<b>COA #</b> <b>2013-COA-278 (CAMA)</b> <b>2013-VHP-017</b>	<b>INDIANAPOLIS HISTORIC PRESERVATION</b> <b>COMMISSION</b> <b>STAFF REPORT</b>	<b>Hearing Date</b> <b>SEPT. 4, 2013</b>
<b>611 E. North Street</b> <b>CHATHAM ARCH &amp; MASSACHUSETTS AVENUE</b>		Continued from:  August 7, 2013   Center Twp. Council District 9 Joseph Simpson
<b>Applicant</b> 611 E. North Street, LLC mailing address: <b>by Donald J. Smith Atty</b> 930 E. 66 <sup>th</sup> Street Indianapolis, IN 46220 <hr/> 611 E. North Street, LLC <b>Owner:</b> 1012 E. 75 <sup>th</sup> Street Indianapolis, IN 46240		
<b>COMBINED CASE</b>		
<b>IHPC COA:</b> 2013-COA-278 (CAMA)	<ul style="list-style-type: none"> <li>• Construction of a new single-family house</li> <li>• Variances of Use and Development Standards</li> </ul>	
<b>VARIANCES:</b> 2013-VHP-017	<ul style="list-style-type: none"> <li>• Variance of Use to allow three single family houses (single-family not permitted in D-10).</li> <li>• Variance of Development Standards to allow a zero foot setback from the south and east property lines and a one foot setback from the west property line.</li> <li>• Variance of development standards for 4 ft north perimeter yard when a

Parking to be removed for driveway (possibly further north)

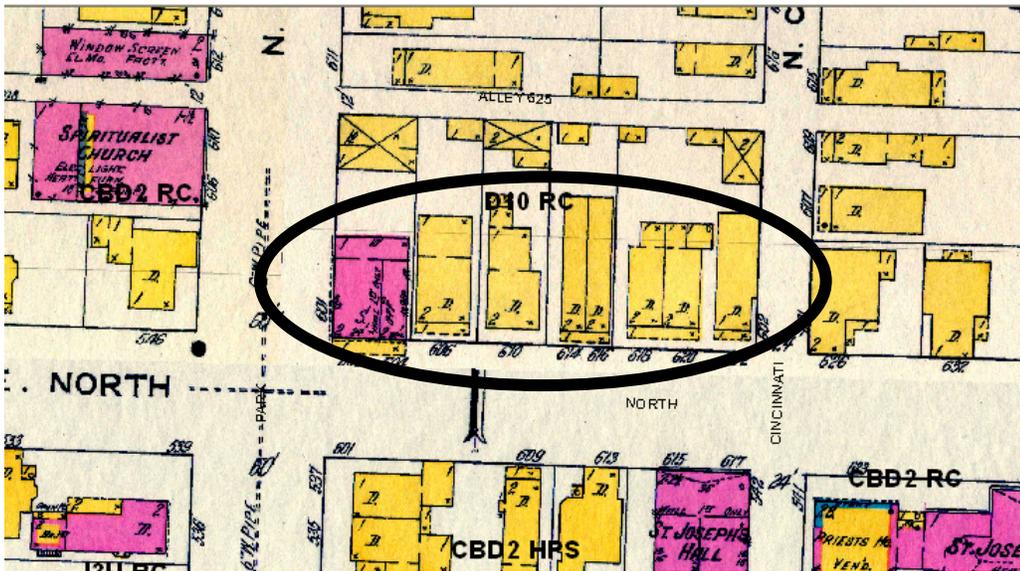
2. Eliminate On-Street Parking. DPW has indicated the proposed driveway could potentially be approved during the permitting process. However, DPW would probably restrict parking on the east side of Park Ave. from the driveway south to the corner as well as north of the driveway for an as-yet-undetermined distance (possibly all the way north to Massachusetts Ave. since the street is too congested even without the new driveway.)

**OPTION 1 – ORIGINAL SITE PLAN (applicant's preference)**

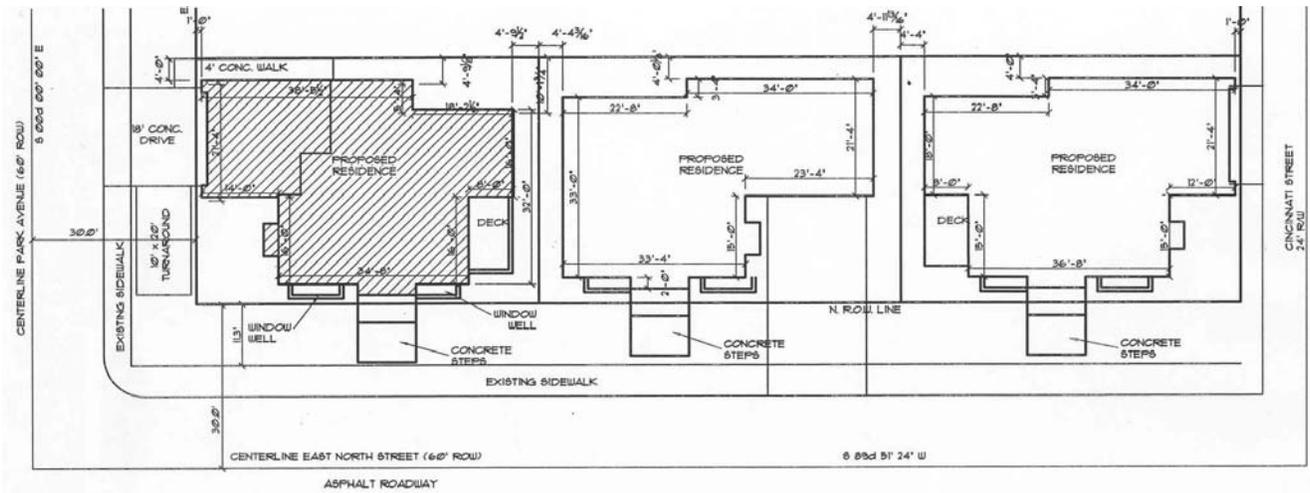
Staff believes that the applicant has addressed the concerns raised by the Commission. While no option is perfect, staff agrees that the applicant’s original site plan, with driveway off Park Ave., is the most practical and offers the best “fit” into the neighborhood, assuming some parking is removed from Park Ave. to increase visibility. Included in this report are the updated drawings and the three site plan layouts discussed above along with the drawings from last month. No changes have been made to the report below.

**OPTION 2 – "T" DRIVEWAY**

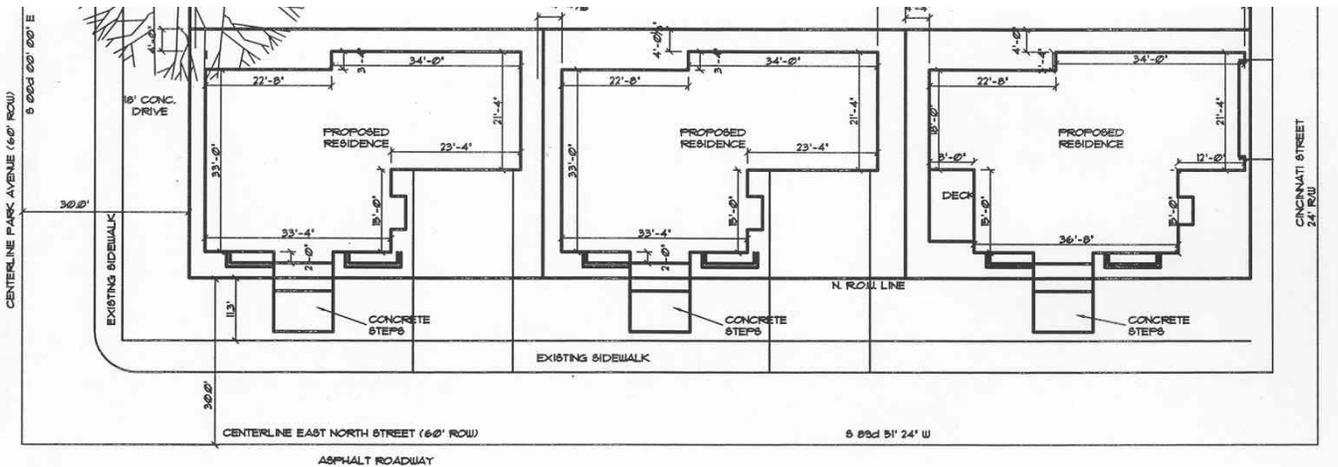
1. **“T” Driveway.** The applicant created a site plan showing a “T” in the proposed driveway that would allow the applicant to turn around and pull forward out of the driveway. However, this is not ideal, as it adds more concrete and less landscaping to the site. It also blocks visibility of the intersection at Park Ave. and North Streets.
